***MODIFICATION REQUEST:
Crowle Home/Achieve Australia Site
Concept Plan***

74-76 Belmore Street, Ryde

MP10_0110 MOD2

Director-General's
Environmental Assessment Report
Section 75W of the
Environmental Planning and Assessment Act 1979

Figure 10: Location of lift overruns for Building B (Source: Proponent's Environmental Assessment).

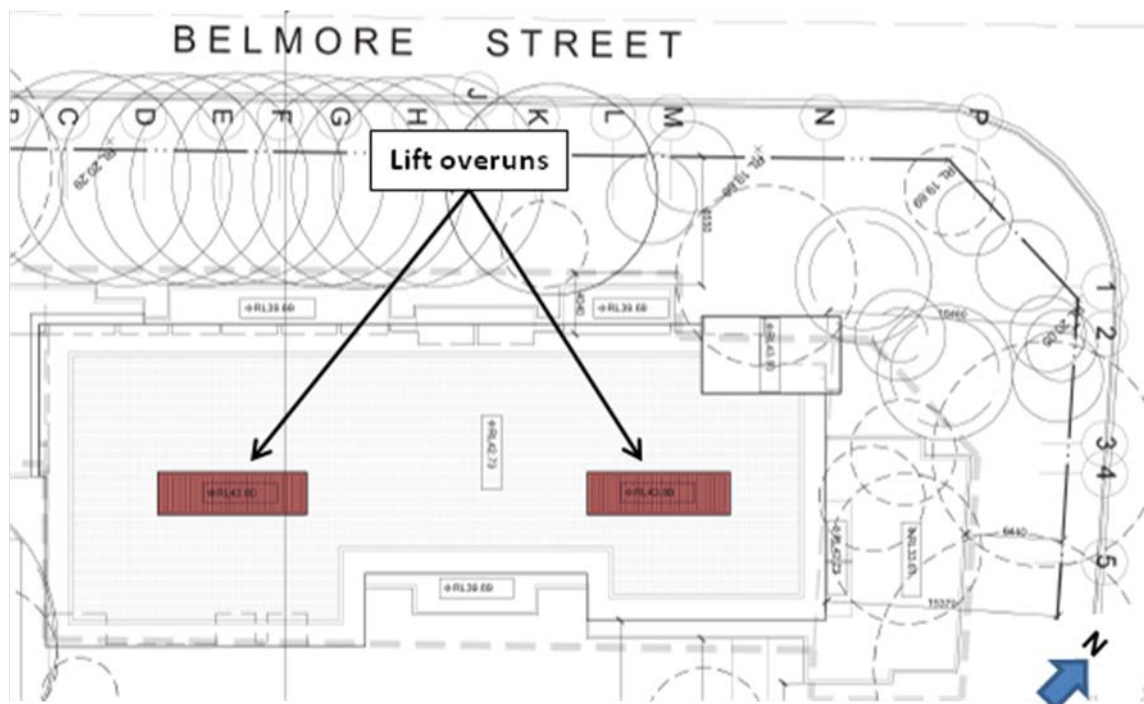
Two lift overruns are proposed for Building B, which are to be centrally located within the roof at the northern and southern halves of the building respectively. The maximum approved height of the building envelope for Building B is RL 43.5 metres (7 storeys) (refer to **Figures 6 and 10**).

The proposal seeks to increase the height of the building envelopes to RL 43.8 metres (being 300mm higher than the maximum height of 43.5 metres) to accommodate the two lift overruns for Building B.

The Proponent, following the detailed design of Building B, has noted with concern that the difference in floor level and natural ground level (the ground floor level is set lower than the natural ground level in this location) could result in flooding issues for the ground floor accommodation and in response has raised the ground floor level (and consequently, the overall height of the building) to address this risk.

Council raised no objection to increase of the height of the lift overruns of Building B by 300mm.

The Department considers the increase of the height of the lift overruns of Building B by 300mm to be modest relative to the scale of the approved building envelope. Furthermore, the resulting lift overruns would be generally obscured from view and not visible from a pedestrian perspective from Belmore Street due to:

- the central location of the lift overruns;
- the low height of the overruns;
- the projection of the architectural features and articulation of the façade of the building; and
- the existence of mature tree planting along Belmore Street.

The proposed modification of the height of the lift overruns for Building B is therefore considered acceptable. It is recommended that A6 be amended accordingly.
